**270 THE PARADE KENSINGTON GARDENS
PEREGRINE CORPORATION MIXED USE DEVELOPMENT**

Final
RESPONSE REPORT

DATE | 7/02/2016

REFERENCE | 64881-4-002

**Peregrine Head Office Development
Solar Diagrams**

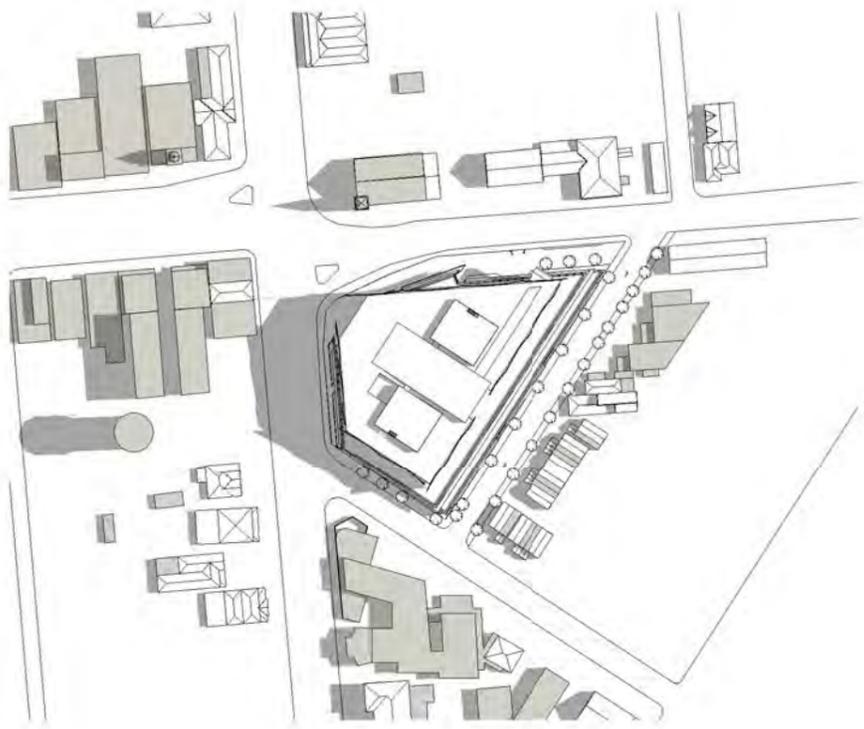
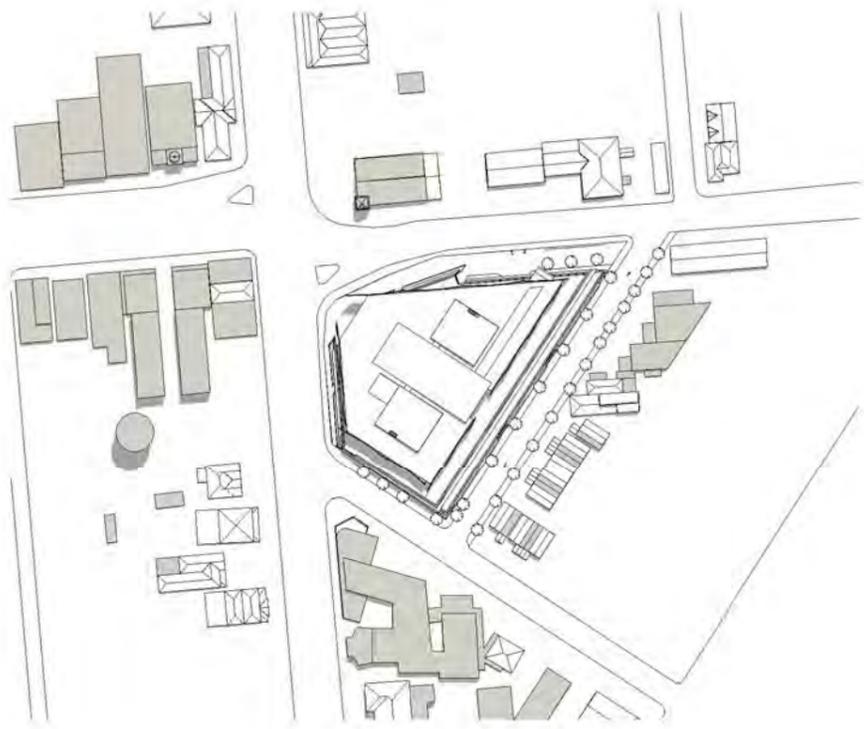
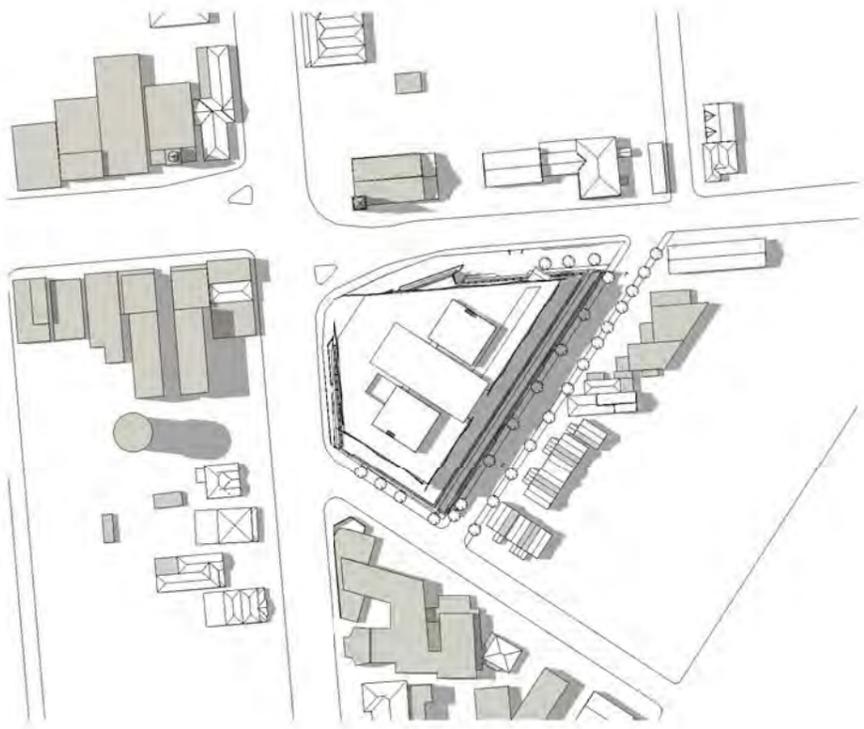
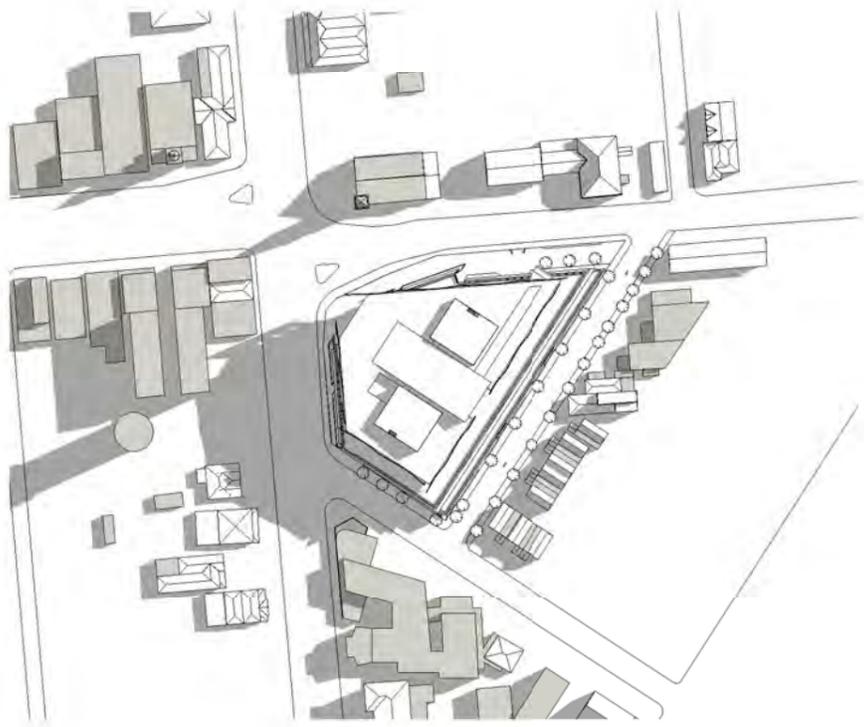
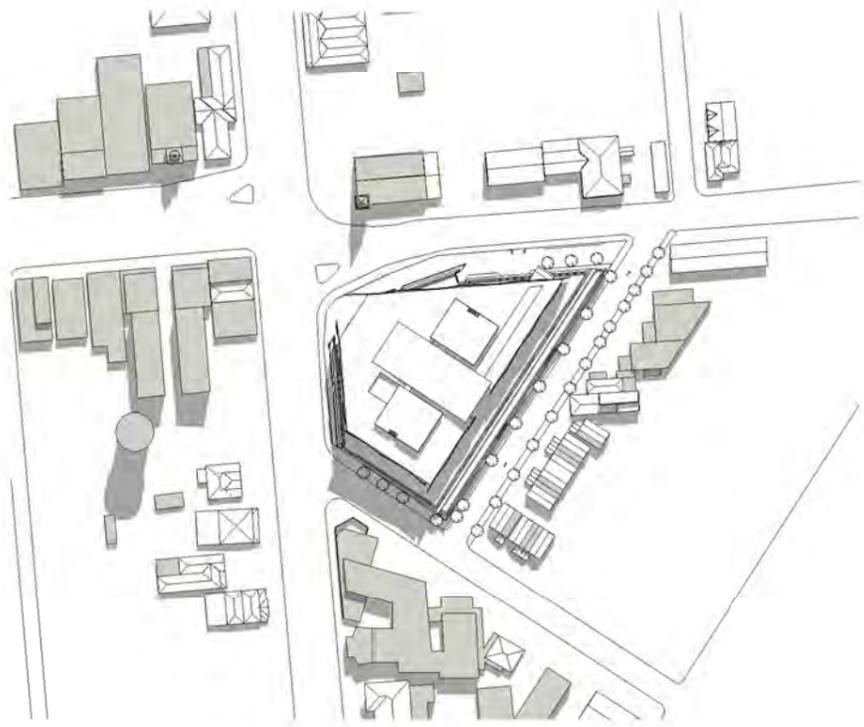
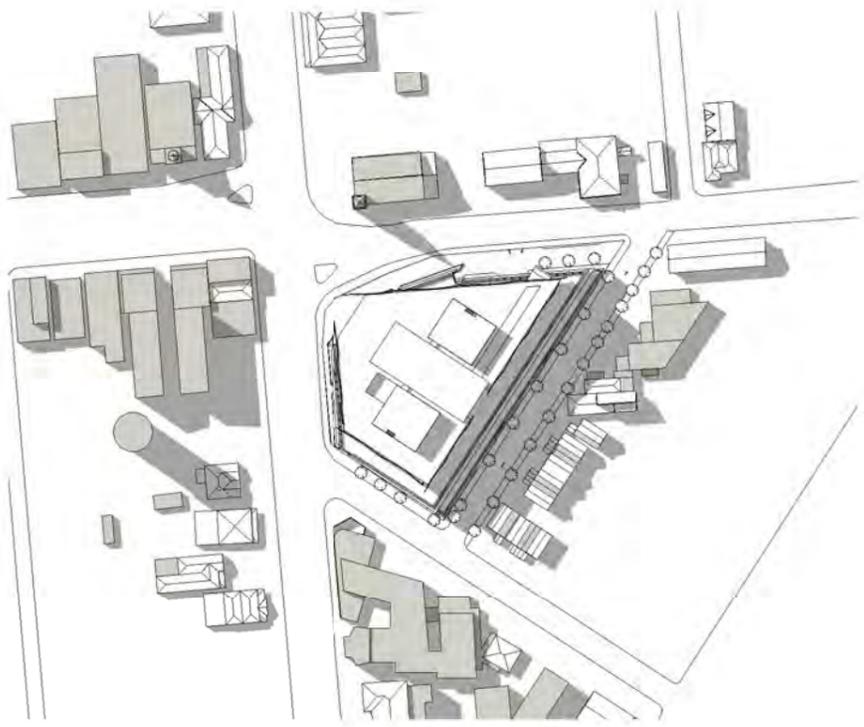
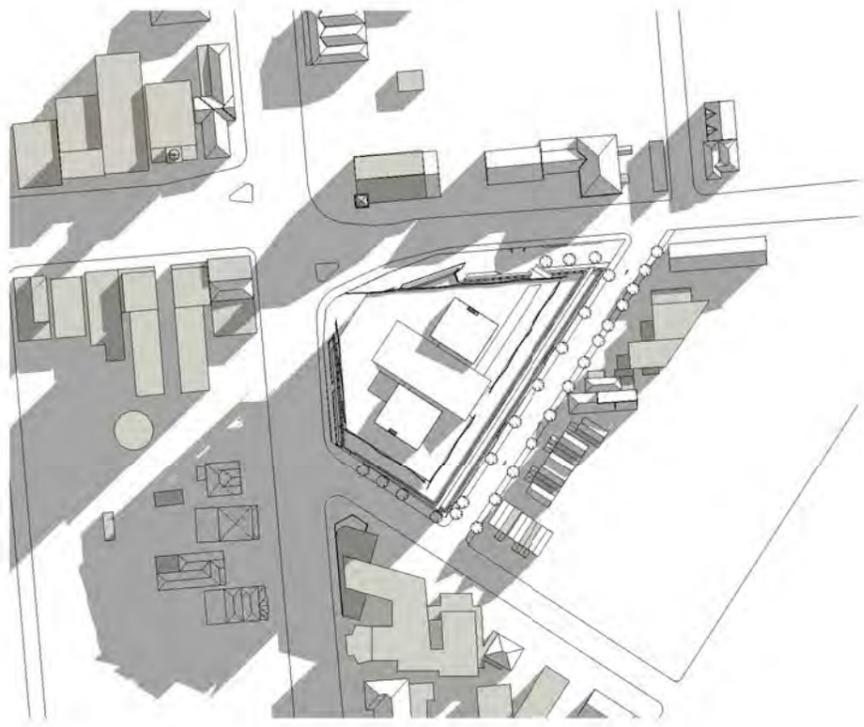
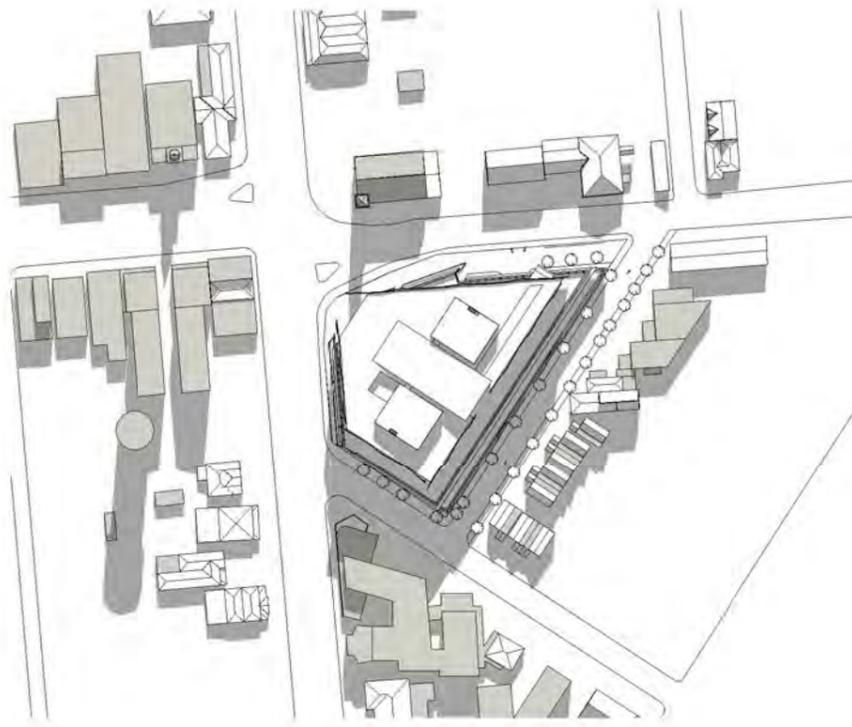
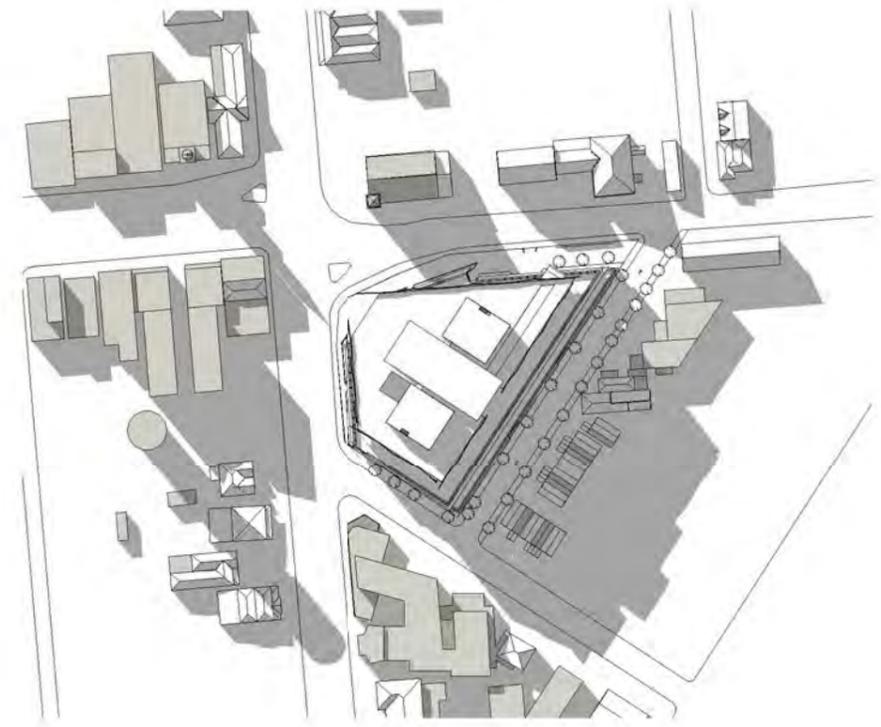
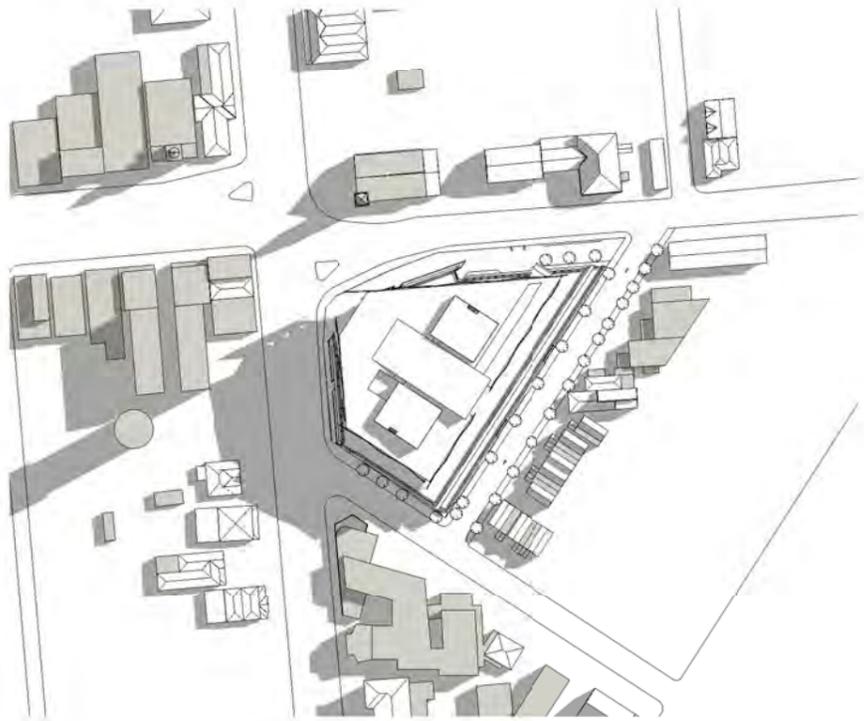
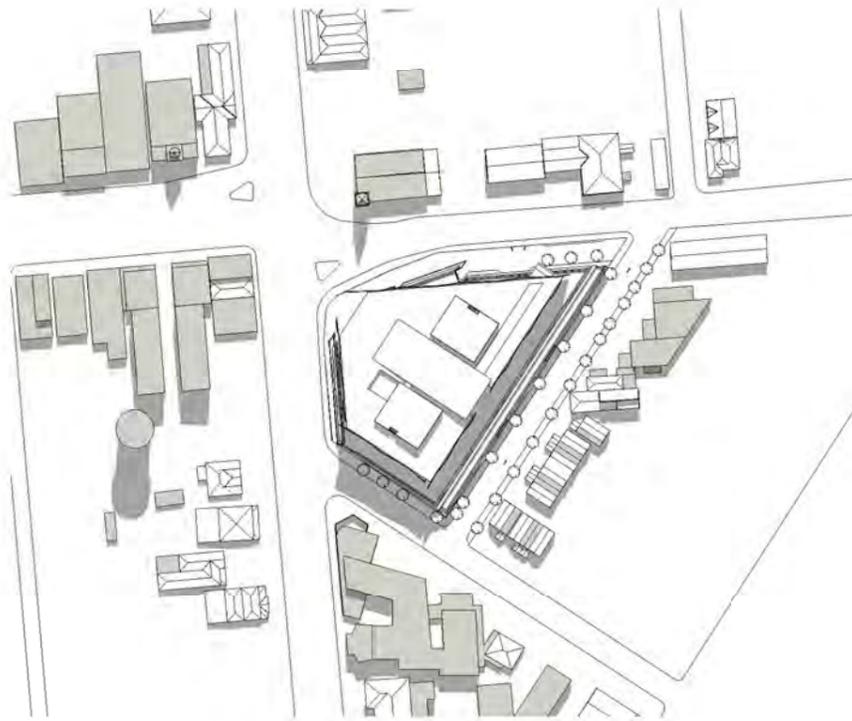
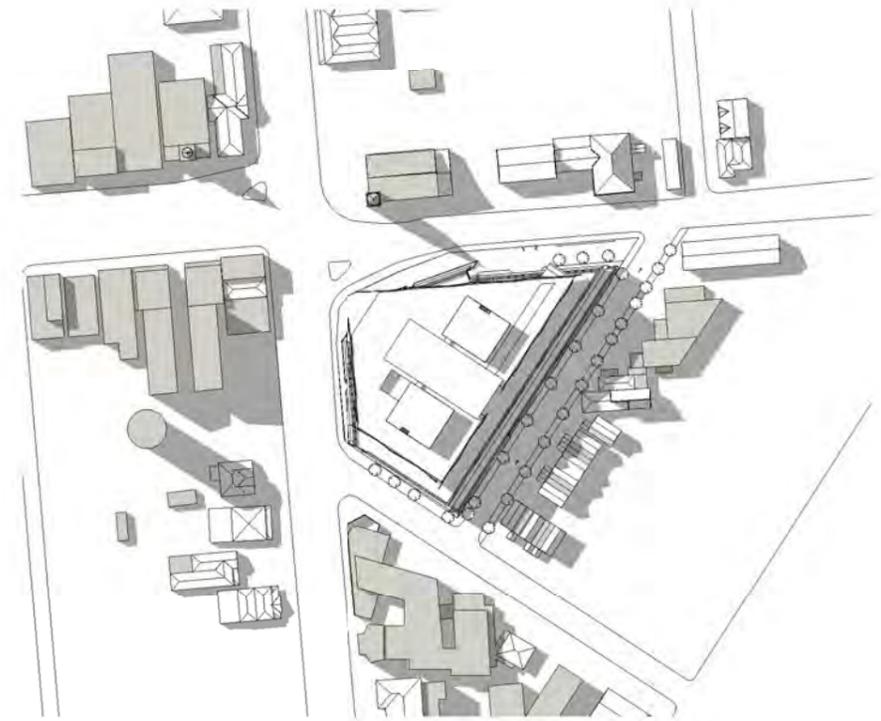
<p>Department of Planning, Transport and Infrastructure</p>	<p>Overshadowing</p> <ul style="list-style-type: none"> - Provide pre-development (ie current) overshadowing diagrams to demonstrate the actual impact of the proposal on overshadowing. - Provide further analysis of the impacts of overshadowing to dwellings on Bowen Street and beyond – High Street and Phillips Street. The DR does not provide a detailed analysis of whether 50% of the private open spaces and 50% of the north facing windows on affected dwellings receive the minimum hours of direct sunlight in accordance within PDC 195 and 196, for both the current situation and the proposed scenario. 	<p>The current office building on the site has parapet heights ranging from 7850mm to 4600mm along High Street, and heights ranging from 4080mm to 6070mm along Bowen Street. At these heights, the current building has no material impact on overshadowing on the residential properties along Bowen Street and beyond. The impacts of the proposal (at the lower height) are shown on the attached solar diagrams.</p> <p>The solar diagrams show that between 9am and noon during the winter, the residents along Bowen Street will have no overshadowing from the proposed development.</p>	<p>The amended plans have reduced the height, scale and visual bulk of the proposal and therefore associated overshadowing impacts. Overshadowing diagrams have been provided as part of Appendix B.</p>

<p>Abuse of planning system</p>	<p>The Development Act makes available the major project assessment path.</p>
<p>Overshadowing/overlooking</p>	<p>The upper storeys are further set back from the podium edge to all main street frontages, with the greatest offset of 11m provided to Bowen Street and the opposing north/east projection towards The Parade and Portrush Road intersection.</p> <p>These measures are designed to mitigate overshadowing and overlooking.</p>

<p>The amended plans have reduced the height, scale and visual bulk of the proposal and therefore associated overshadowing impacts.</p> <p>Amended shadow diagrams have been prepared to assist in the assessment of the amended design and are attached in Appendix B.</p>
Reflections from the proposed building will effect visibility at this intersection and have an adverse impact on road safety.	<p>The risk of potential reflection at ground level is difficult to measure. We note, at the podium level the building is constructed of sandstone, being a non-reflective material.</p>
Hours of operation – restaurant & fitness centre – impact on noise, light and traffic.	<p>This has been assessed and addressed through the various expert reports submitted as part of the application.</p>
Declining home values	<p>There is no objective evidence to support this proposition. This is not a relevant planning consideration.</p>
